Technical Service Bulletin: TSB150118

Implementation of Coolant Tee Adapter to Reduce Engine Shutdown Complaints

Figure 1, Coolant Tee Adapter with Engine Coolant Temperature Sensor and Engine Coolant Temperature Switch

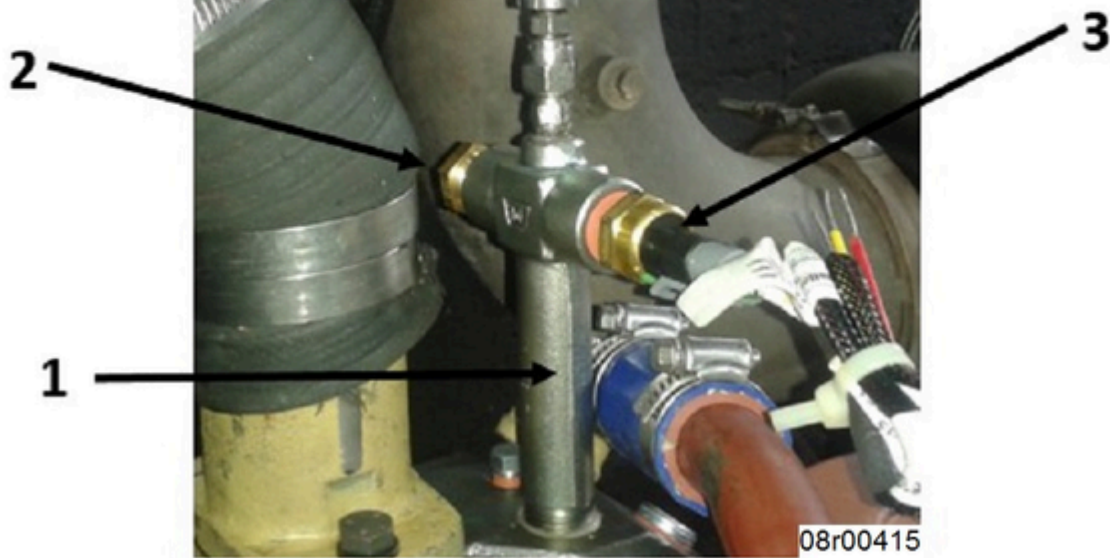
This document announces the factory installation of a tee adaptor to mount both the engine coolant temperature sensor and engine coolant temperature switch farther from the engine.

Engines can shut down as a result of false high coolant temperature readings caused by the engine coolant temperature sensor and engine coolant temperature switch being exposed to excessive levels of radiant engine heat. Mounting the engine coolant temperature sensor and engine coolant temperature switch on the coolant tee adaptor limits their exposure to the radiant engine heat.
